August 17, 2017

**RE: Lot 11 Block 6 Unit 22, S.A.D. 228
Volcano Cliffs Subdivision
6200 Camino Alto NW
Grading and Drainage Plan
Engineers Stamp Date 8-13-17 (D10D00B11)**

CANDELARIA - STENZEL- GRADING & DRAINAGE PLAN

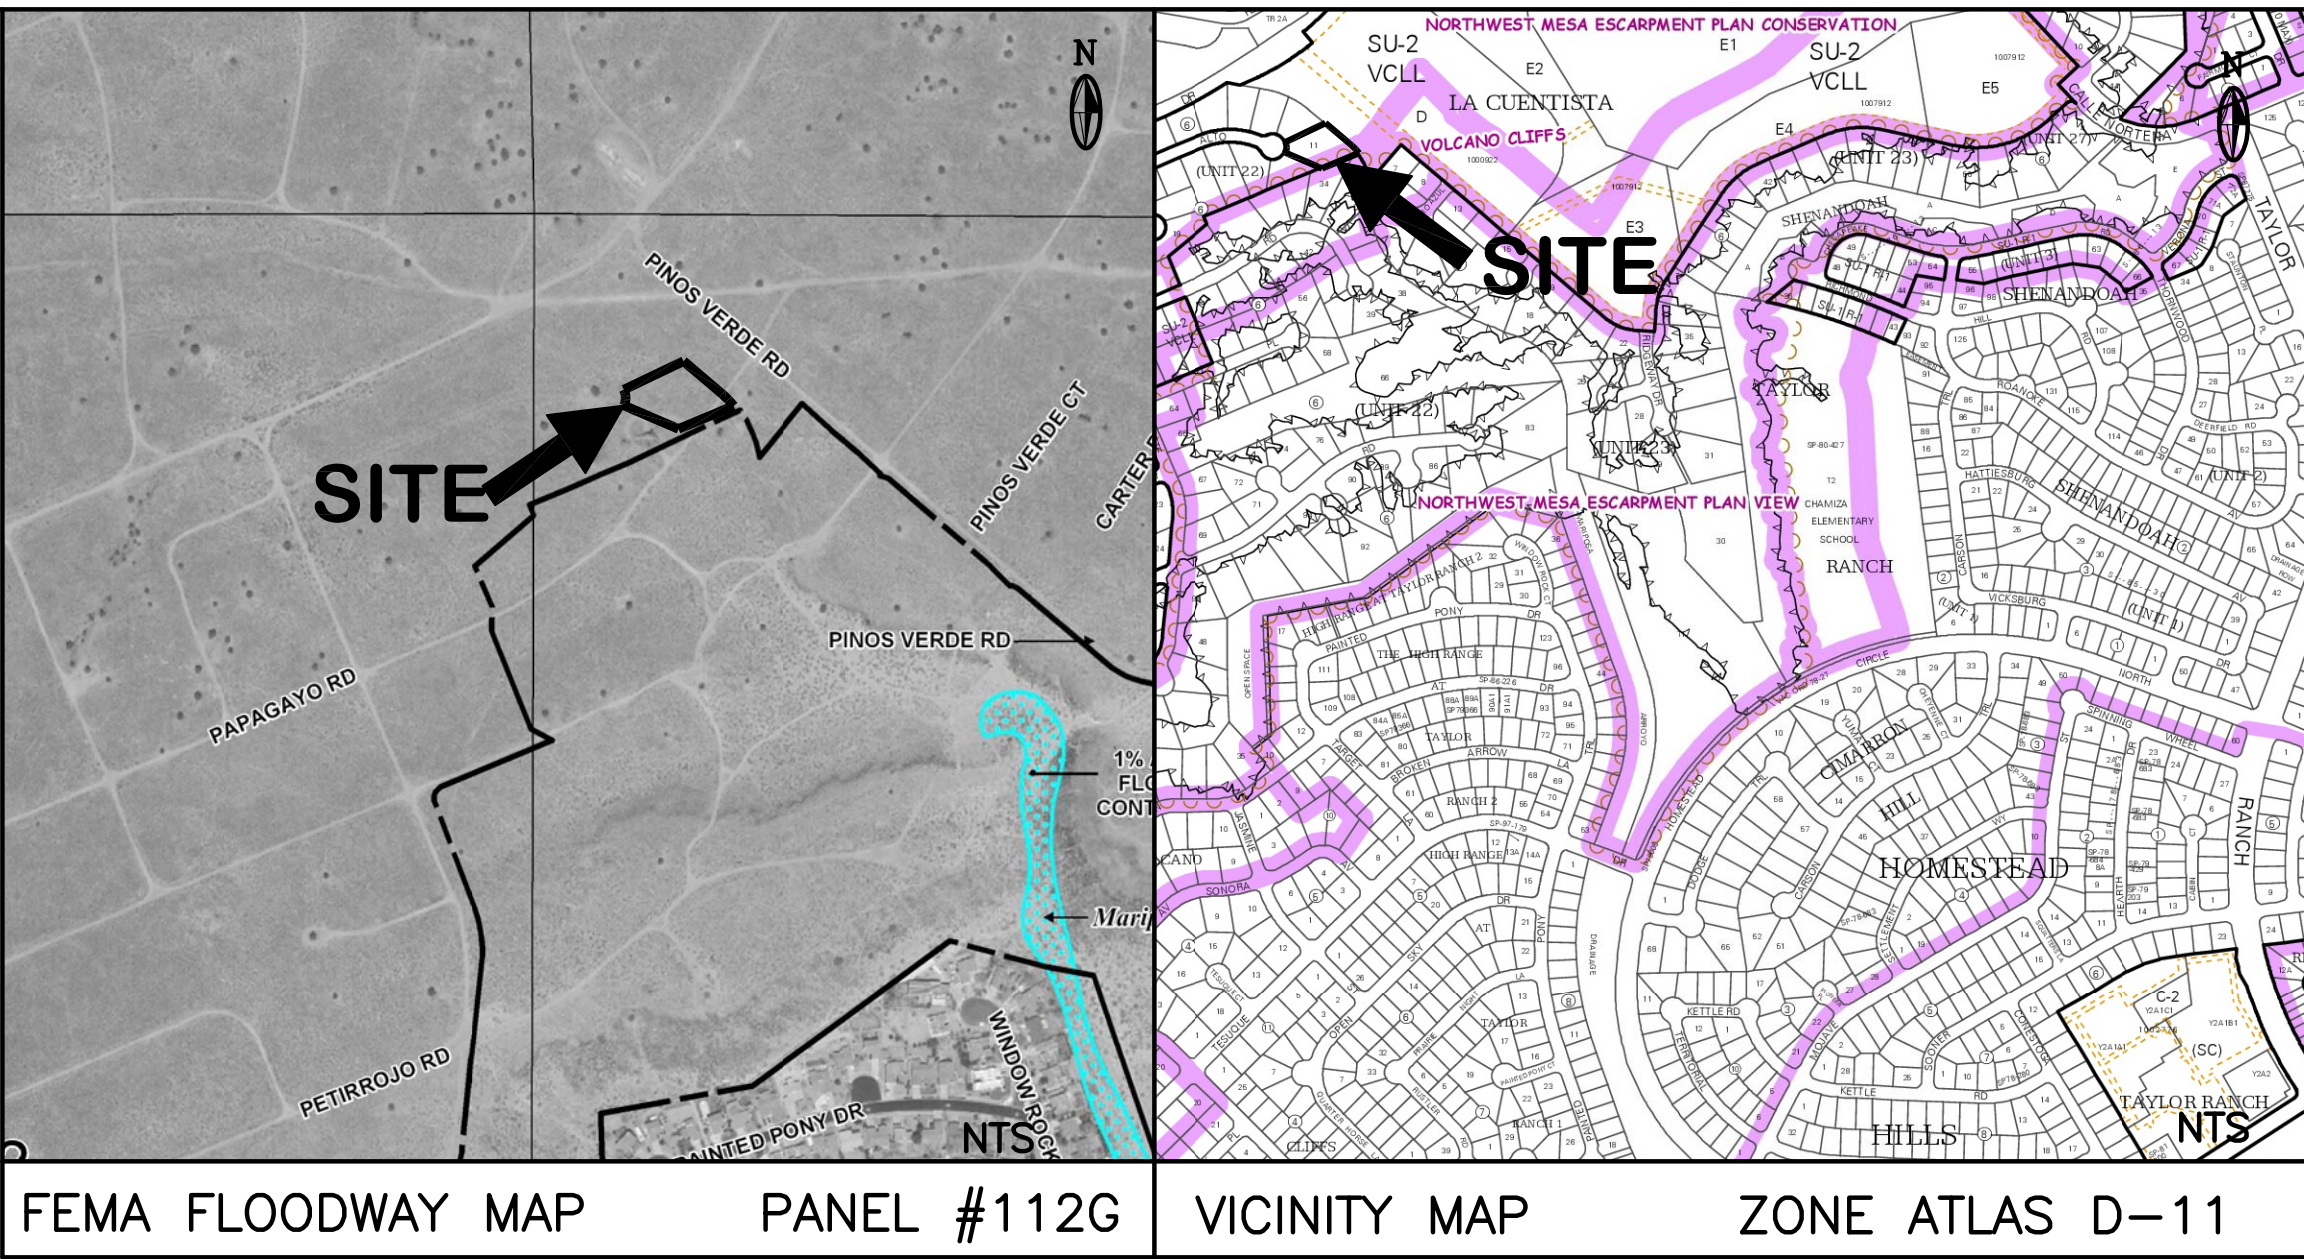
Based upon the information provided in your submittal received 8/15/17, this plan is approved for Grading Permit. Please be advised that, before the building permit can be issued a PAD Certification must be approved

Please have the owner/builder attach a copy of this approved plan, to the construction sets in the permitting process prior to sign-off by Hydrology.
